**Minutes of the Meeting
June 18, 1998**

061898.1 Project: **Apprenticeship Training Center**
 Phase: Schematic
 Presenters: Nettie Dokes, Seattle City Light
 Jeffrey Floor, Arai/Jackson Architects and Planners
 Neal Knapper, Seattle City Light
 Paul Marioni, artist
 Time: 1 hr. (0.3%)

Plan and east elevation

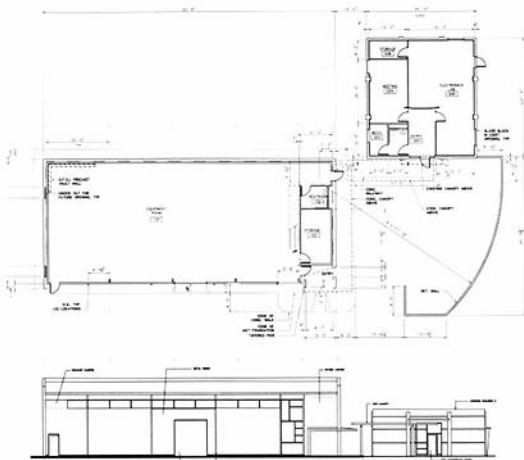
- Darwish:** Why don't the two entry canopies have matching materials and character? It seems like a way to tie the new and existing buildings together.

- Dubrow:** I appreciate your efforts to foster a unified work force with shared restrooms. I also agree with Carolyn about connecting the two buildings. They seem to need more integration. There seem to be opportunities to celebrate dramatic activities making them publicly accessible through the building facade treatment. The new building also seems to need more integration between the metal facade and the concrete shell. Will there be any landscaping in the project?

- Sundberg:** I also agree with the previous comments regarding the canopies. They are a simple opportunity to link the two buildings together. I admire the directness of the project and the efforts to re-use the rectifier building. It would be interesting to see the climbing tower as part of the composition. I encourage showing these activities when possible. I also recommend a higher concrete curb below the metal siding. The metal siding close to the ground will get dented and beat up quickly and a more significant curb may be a way to weave the facade together with the concrete shell.

- Dubrow:** There may also be an opportunity to pull back the concrete wall near the northeast entrance. This would expose more glazing and one of the pole tops to the outside as well as creating an opportunity to integrate the facade with the concrete shell. Is there a realistic opportunity for refinement within the budget constraints?

- Floor:** They are intentionally contrasted in material and character to distinguish between the old and new buildings. The concrete canopy needs more mass to achieve the necessary cantilever than the steel canopy. They could be more similar.

- Floor:** We thought of the metal facade as the tender underbelly of the building that contrasts with the concrete shell. We haven't discussed landscaping, but most of the outdoor spaces require truck access. We initially wanted to have glazing in the east facade behind the pole top areas, but it wasn't feasible after the budget was reduce by one-third. We tried to emphasize the contrast between the two canopies, but will reconsider that approach.

- Floor:** The more significant constraint is the schedule. City Light wants the building ready for training in 1999. There is not a lot of opportunity for redesign, but there is some for refinement. I like the idea of the glazed corner, but the acoustical engineer won't support it.

- **further integrate the two new canopies as a way of weaving together the new and existing buildings;**
 - **further develop the metal facade with a higher concrete curb for increased durability and as a way of weaving together the metal facade and concrete shell;**

Street level plan

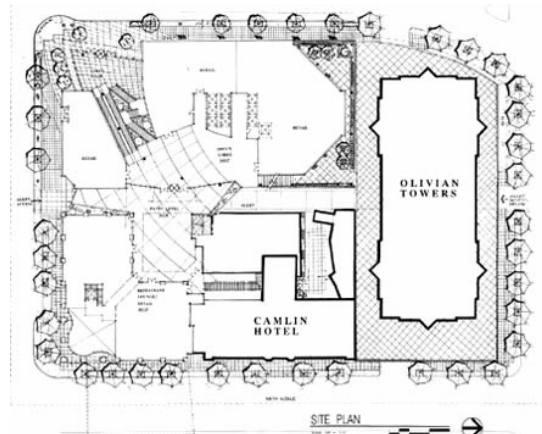
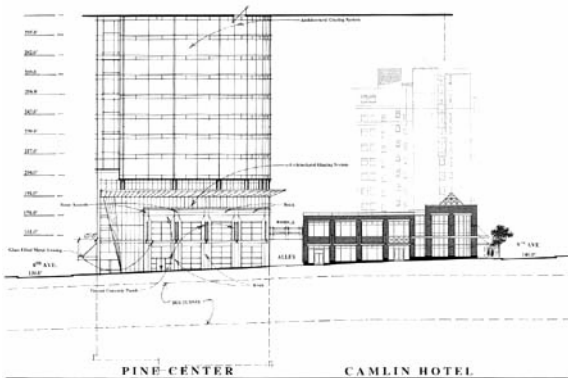
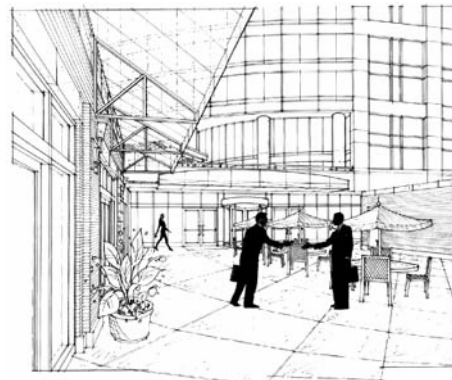
- Dubrow:** It is in the City's best interest to encourage street vitality and to discourage secondary circulation routes within private developments. I encourage you to explore access to the plaza from the south side.

- Swift:** The Pine Street Task Force document would be a good tool for ideas and implementation.
- Foley:** Downtown blocks seem to be losing a sense of rhythm and scale as alleys are eliminated or covered. Is there an opportunity to pull the skybridge back away from the south facade, reinforcing the rhythm of Pine Street?

- Batra:** pulling the balcony back from the south facade may reveal the plaza activities better.
- Swift:** The Downtown Land Use and Transportation Plan is a resource for evaluating skybridge permit requests.

- Darwish:** I am concerned that the plaza will not be an obvious public space.
- Dubrow:** In terms of the criteria, I still think that B and C are not adequately met. The skybridge is not required for safety reasons because people should be crossing the alley at the sidewalk. It is still at a marginal level.

Action: The Commission recommends approval of the skybridge with the following conditions.

- pull back the skybridge from the south edge to reinforce alley opening;
- the sidewalk treatment must conform to the City standard, the Pine Street Advisory Task Force recommendations, and to any other neighborhood plan being developed;
- the plaza must be developed with improved visibility and wayfinding to ensure public use and accessibility;
- the Commission would like to see a later presentation of the project with these conditions met.

Streetscape Improvement Plan

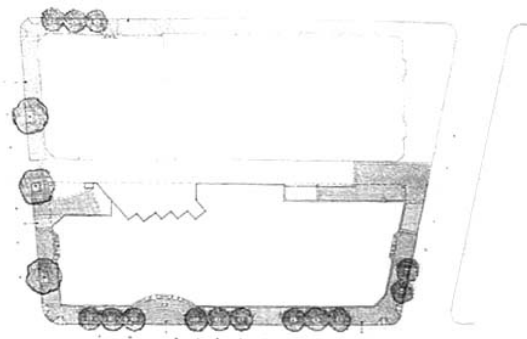
Layzer: The approach to the streetscape appears to be more of an embellishment to the building than to the public realm.

Swift: I am also concerned about the streetscape. I would rather see an approach that encourages lingering along the sidewalk. I am also concerned about the egress onto Stewart Avenue which appears to be a widening of the alley opening. I would rather see the parking garage exit into the alley or have the exit onto Stewart moved away from the alley.

- Layzer:** I don't want to undervalue the importance of affordable housing in the downtown core, but I don't feel that the effort made to provide streetscape enhancements meets my expectations. Improvements could also extend beyond the site boundaries.

- **pursue further development of public benefits beyond those tied to FAR bonuses;**
 - **develop the streetscape environment with attention to public amenities such as seating, transit shelters, drinking fountains, donations to the public arts fund, and others that may be identified in Neighborhood Planning efforts.**
